COMMITTEE OF ADJUSTMENT

NOTICE OF PUBLIC HEARING
Minor Variance

| APPLICATION NO.: | A-24:227 | SUBJECT PROPERTY: | 1160 Edgewood Rd, Flamborough |

Re: **APPLICABLE LAW REVIEW – ZONING BYLAW**
Present Zoning: A2
Address: 1160 EDGEWOOD RD FLAMBOROUGH, ON

Site Plan
A1.01

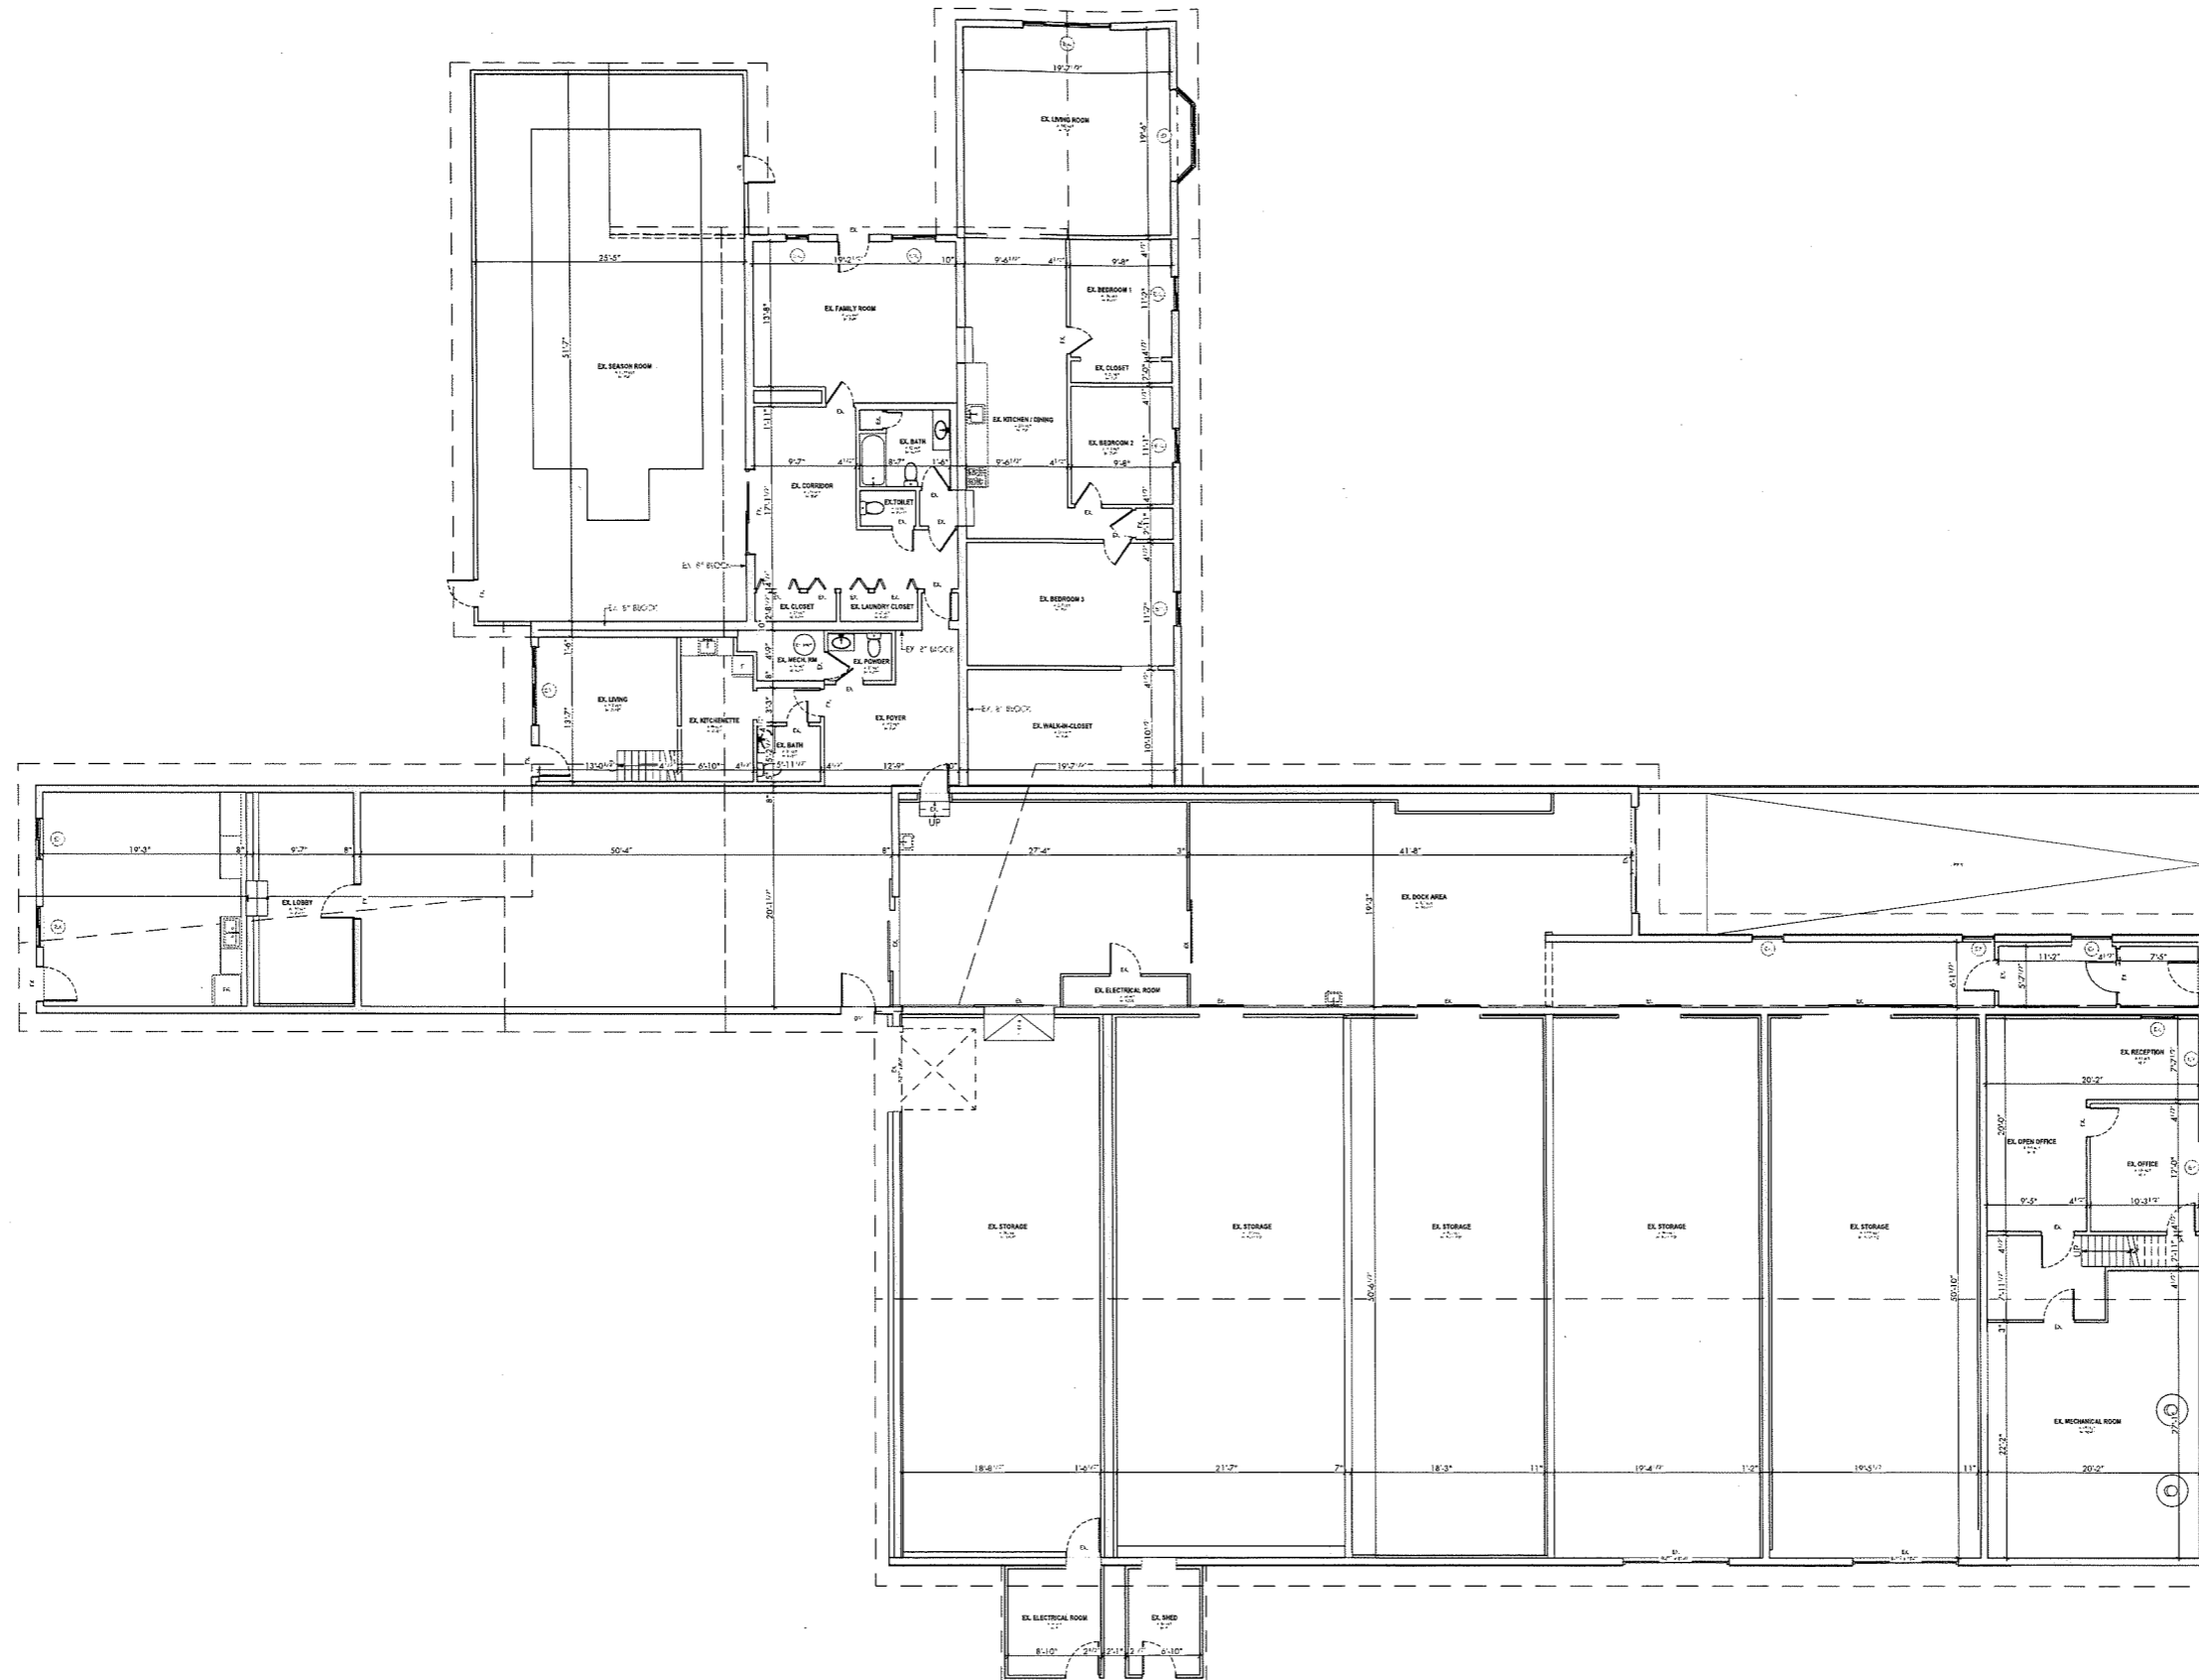
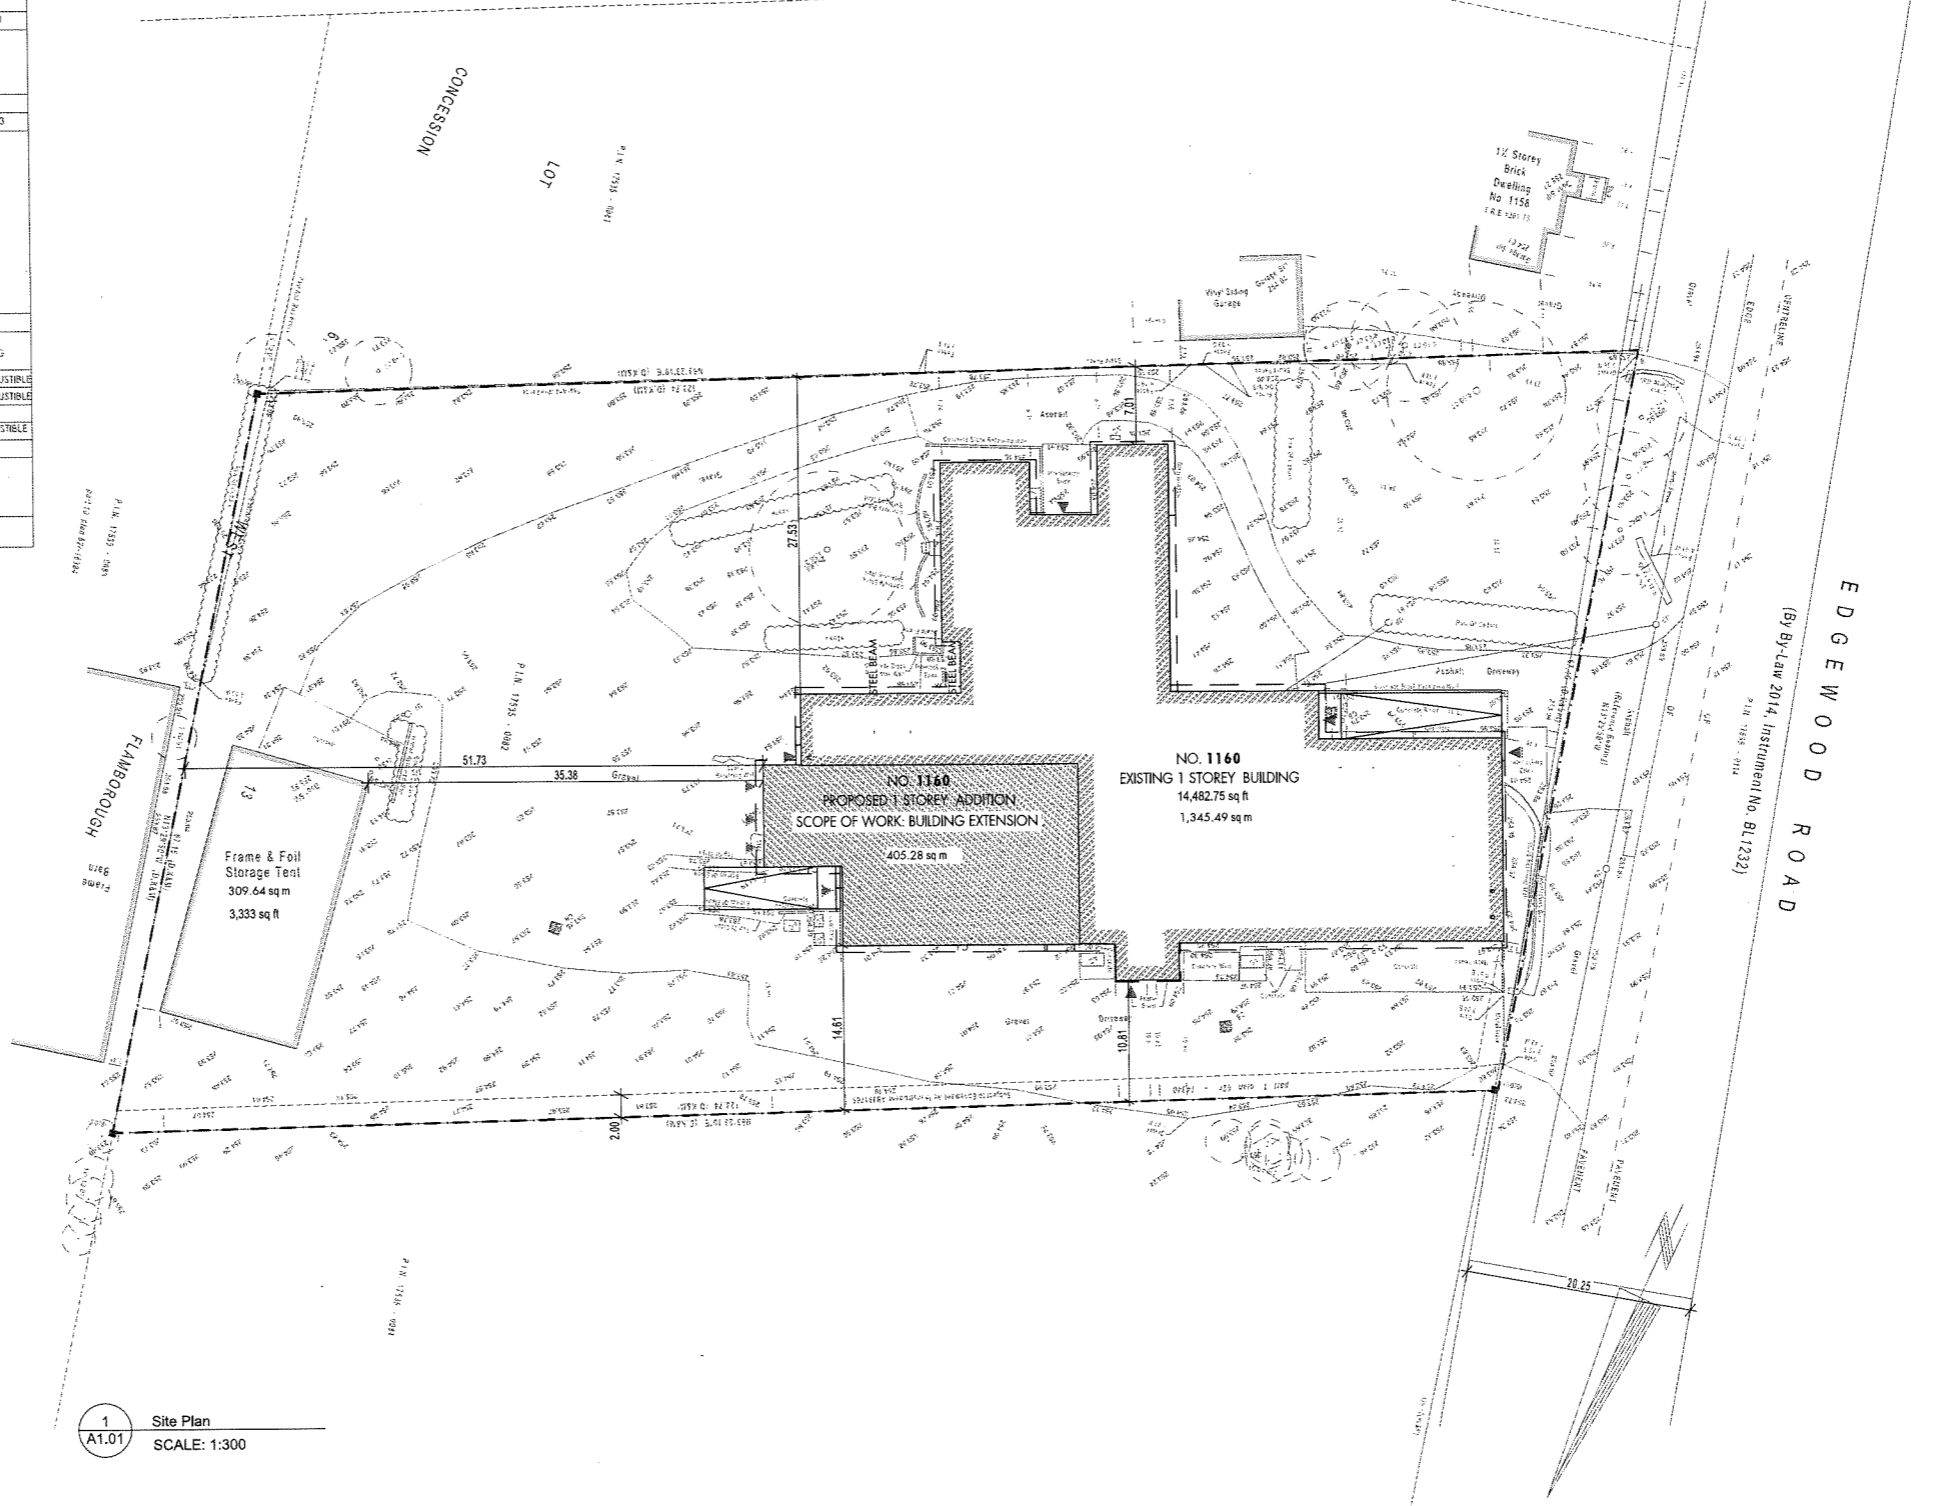
| | Required By The By-Law | Provided | Conforming/ Non-Conforming |
|---|---|--|--|
| Minimum Side Yard [as per section 12.2.3.1(c) of Hamilton Zoning By-law 05-200] | 15.0m | existing southerly side yard to remain southerly side yard of 14.63m provided | non-conforming |
| Maximum Lot Coverage [as per section 12.2.3.1(e) of Hamilton Zoning By-law 05-200] Committee of adjustment decision FL/A-19:43 | i) 20% a maximum lot coverage of 23.5% shall be permitted instead of 20% maximum lot coverage permitted | total lot coverage of 25.41% provided as per site statistics | Non-Conforming |

| | Required By The By-Law | Provided | Conforming/ Non-Conforming |
|--|--|--|-------------------------------|
| <p>Mushroom Operations [as per section 12.2.3.1(k) of Hamilton Zoning By-law 05-200]</p> <p>Committee of adjustment decision FL/A-19:43</p> | <p>i) Notwithstanding Sections 12.2.3.1 b), c), and d) above, any buildings or structures used for a Mushroom Operation shall be set back a minimum of 30.0m from any lot line;</p> <p>a setback of 15.2m from the northerly lot line shall be provided whereas the by-law requires a minimum 30.0m from any lot line to be provided for a mushroom operation</p> | <p>14.63m setback provided to the northerly lot line</p> <p>34.54m setback provided to southerly lot line</p> <p>35m setback provided to the rear lot line</p> | Non-Conforming |
